**RE: 813-913 WALLGROVE ROAD, HORSLEY PARK - FLOOD IMPACT ASSESSMENT ADDENDUM**

This addendum is prepared in response to the Department of Planning, Industry and Environment's (DPIE) recommendations (DOC21/65477 included as Appendix A) for the proposed 'Gazcorp Industrial Estate' development at 813-913 Wallgrove Road, Horsley Park ('the Site'). A Flood Impact Assessment (FIA) was previously undertaken by BMT for the site (R.M20101.001.01.ModellingReport.pdf included as Appendix B) and was submitted in November 2019 as part of a State Significant Development application (SSD-5248). The proposed development design based on this submission is referred herein as the 'approved design'. In December 2020, Gazcorp submitted an application to modify the approved design and this proposed development design is referred to herein as the 'modified design'. This addendum outlines the assessment of the effect of the modified design on the site flood behaviour and for adjoining properties.

**Subject: Gazcorp Industrial Estate Modification 1 Revised Layout and Earthworks, 813-913 Wallgrove Road, Horsley Park (SSD 5248)**

**Figure 1 Gazcorp Industrial Estate – Approved Design (November 2019)**

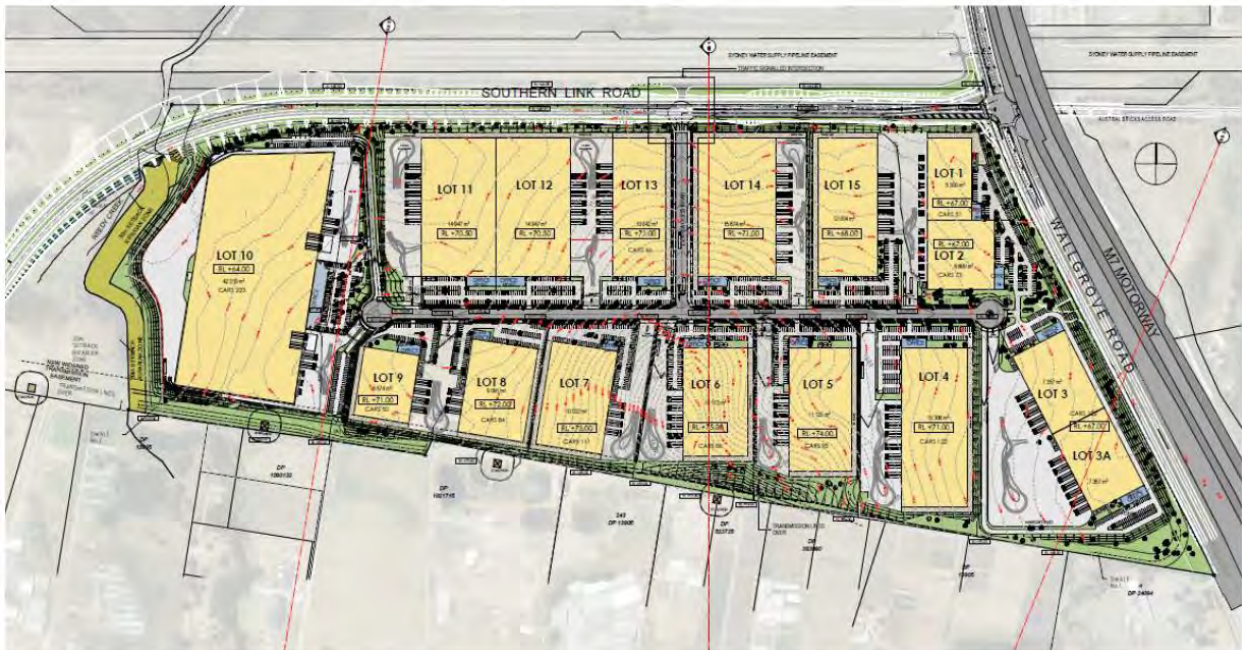
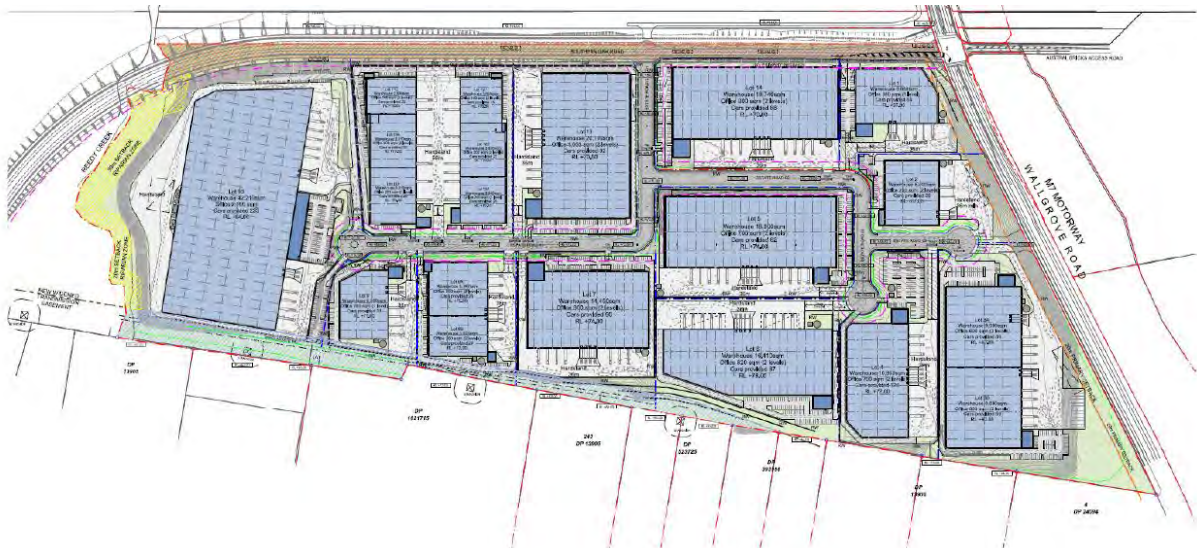
- The Lot 10 footprint indicates that the western and north-western sides of Lot 10 would encroach into the Reedy Creek floodplain; and
- Any filling activities along the western and north-western sides of Lot 10 are likely to impact existing flood storage. Filling activities would cause Reedy Creek to become a hydraulic bottleneck in this location, which would have adverse flooding impacts on Lot 10 and upstream catchment areas.

DPIE recommended the undertaking of "a comprehensive analysis by using the flood models for the Reedy Creek Catchment to evaluate storage loss in the floodplain and flooding impacts at Lot 10 and its adjoining

*areas in order to identify the appropriate measures to mitigate adverse flooding impacts in the post-development conditions of the development site.”*

As outlined above, the modified design does not propose any changes to the approved design at Lot 10. Accordingly, there would be no change in how the western and north-western sides of Lot 10 encroach into the floodplain of Reedy Creek in the modified design when compared to the approved design. The previous FIA assessed the approved design using the flood models developed for the *Rural Area Flood Study – Ropes, Reedy & Eastern Creeks* (BMT WBM, 2013) to evaluate potential flood impacts. It is therefore considered that:

- The flood conditions outlined in the previous FIA (which was undertaken for the approved design) would be applicable to the modified design at the western and north-western sides of Lot 10 and in Reedy Creek; and thus
- The previous FIA provides a comprehensive analysis of the potential flood impacts of the modified design on Reedy Creek in line with DPIE’s request.
